In the Matter of)
)
COMMONWEALTH EDISON COMPANY) Docket No. 50-454 OL
) 50-455 OL
(Byron Station, Units 1 and 2))

AFFIDAVIT OF KENNETH A. AINGER

COMMONWEALTH EDISON COMPANY
BYRON AND BRAIDWOOD STATIONS - UNITS 1 AND 2
Deletion of Non-Damped Check Valve from Steam
Generator Preheater Bypass Line

Figure Main Feedwater Bypass Arrangement (Reverse Flushing, Alternate Tempering Arrangement)

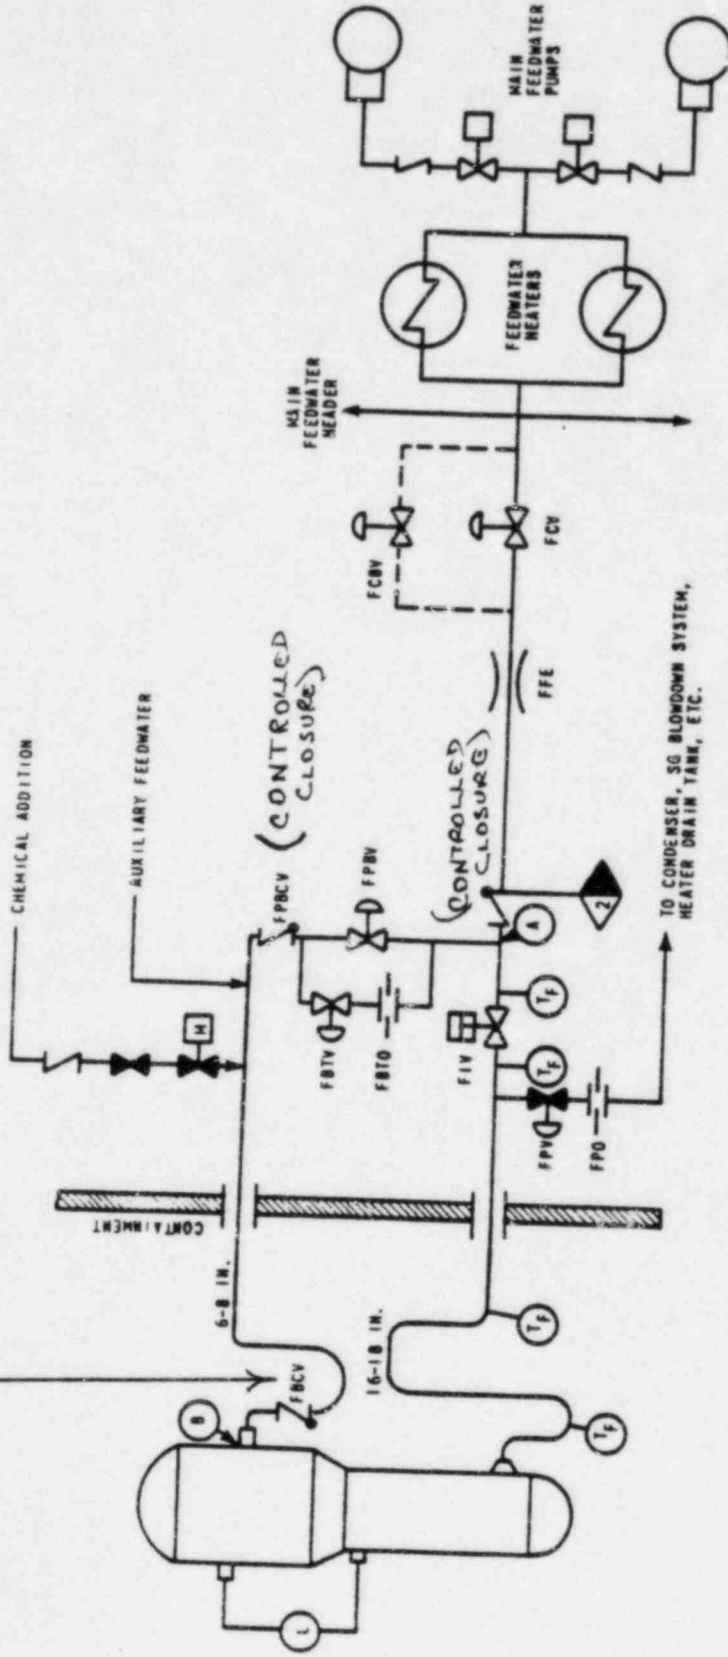
Non-damped check valves in the steam generator feedwater and bypass line have been replaced with controlled-closure check valves as identified in the attached figure. At the present time, the non-damped check valve closest to the steam generator auxiliary nozzle still exists. A review of this arrangement indicates that, as a consequence, the non-damped check valve closest to the steam generator auxiliary nozzle is redundant and would act to defeat the purpose of installing the controlled-closure check valves, which is to substantially reduce the severity of the feedline break/check valve slam transient. Therefore, the non-damped check valve (identified in the attached figure) should be made inoperable. This can be accomplished by either removing the entire check valve from the pipe or by removing the internal disc from each of the identified check valves.

Check Valve to be Made Inoperable
